## **Avolites Ltd.** Engineering Change Notice

Pearl Expert DMX Earth Connection
ECN-0184
Pearl Expert
Adam Proffitt
13/10/08

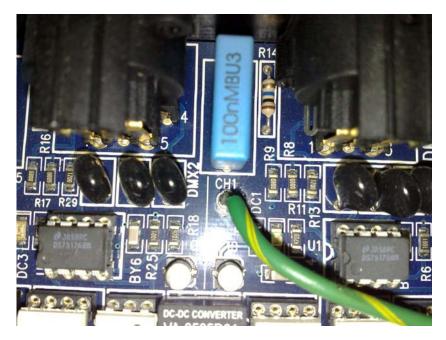
Reason for ECN	Noise induced into DMX cables causes desk USB errors.
Special Parts required	2 off M3 crimp eyes, 2 off 12cm lengths of 32x0.2mm wire.
Special Tools required	M3 nut runner. Soldering iron and solder.

1. Turn off and open the desk.

2. Locate the desk lamp socket connections on the desk output panel - between the U-DMX circuit boards.

- 3. Undo the M3 nut which secures the earth connection to the desk lamp socket.
- 4. Crimp an M3 eye onto each of the 12cm lengths of cable. If M3 eyes are not available then the bare wire ends will have to be securely clamped behind the lamp socket eye.
- 5. Solder the other end of the wire into the CH1 hole on the U-DMX circuit boards.

6. Secure all 3 wires behind the nut. Check that the eyes will not move.

7. Close the desk.
